Technical Memorandum

To: Mr. Mark Lipan
From: Sheila D. Rayman, P.E.
Date: 11/19/2021
Re: 2022 Englewood Drive Improvement Project Addendum 3

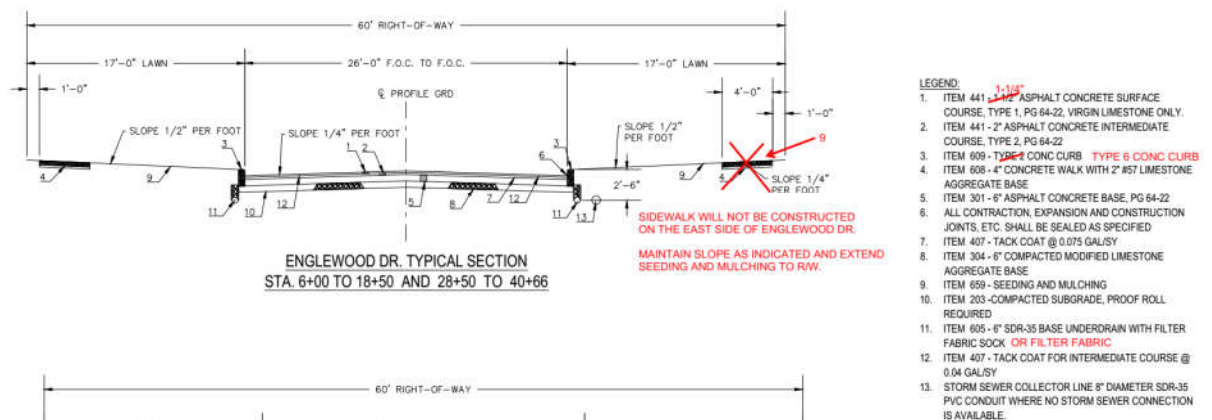
- The plans will be amended to **REMOVE** the concrete walk and curb ramps from the **EAST SIDE** of Englewood Drive. The typical section will be maintained as to grade and the seeding and mulching will extend to the right-of-way.

- Proposal Item No. 50, 605 6" Underdrain:
 Refer to Typical Section, Plan Sheet 18, for detail on 6" underdrain.
 The contractor may wrap underdrain with filter fabric, as indicated in the Proposal Form, or filter sock called out in the Typical Section, Plan Sheet 18. The legend on Plan Sheet 18, No, 11 will read: ITEM 605 - 6" SDR-35 BASE UNDERDRAIN WITH FILTER FABRIC OR FILTER FABRIC SOCK.

- Cross sections will not be provided at this time. Please bid the quantity indicated in Proposal Item 23, Excavation and Embankment.
- Proposal Bid Item 29, Asphalt Concrete, Surface Course, Type 1, Medium, PG 64-22, 1-1/4" Thick: Depth of 1-1/4" is correct. The legend on Plan Sheet 18, No, 1 will be revised to indicate 1-1/4" rather than 1-1/2" as indicated on the Bid Set.

7. Proposal Item 60, Item 611 Catch Basin should indicate CB-3 and not CB-3A. This has been revised on the attached updated Proposal Form.
8. The proposed concrete curb is ODOT Type 6, indicated as 6" x 18" on the Proposal Form, Bid Item 34.
9. There is no historic soil data available for areas located within the project limits.
10. For the purposes of bidding, please include section 611.04 as required within Item 611.
11. The following red-marked typical section is being provided for clarification of modifications identified in the addenda issued.

- LEGEND:**
1. ITEM 441 - ~~1-1/2"~~ ^{1-1/4"} ASPHALT CONCRETE SURFACE COURSE, TYPE 1, PG 64-22, VIRGIN LIMESTONE ONLY.
 2. ITEM 441 - 2" ASPHALT CONCRETE INTERMEDIATE COURSE, TYPE 2, PG 64-22

3. ITEM 609 - ~~TYPE 6~~ ^{TYPE 6} CONC CURB
 4. ITEM 608 - 4" CONCRETE WALK WITH 2" #57 LIMESTONE AGGREGATE BASE
 5. ITEM 301 - 6" ASPHALT CONCRETE BASE, PG 64-22

9. ITEM 659 - SEEDING AND MULCHING
 10. ITEM 203 - COMPACTED SUBGRADE, PROOF ROLL REQUIRED
 11. ITEM 605 - 6" SDR-35 BASE UNDERDRAIN WITH FILTER FABRIC SOCK ~~OR FILTER FABRIC~~
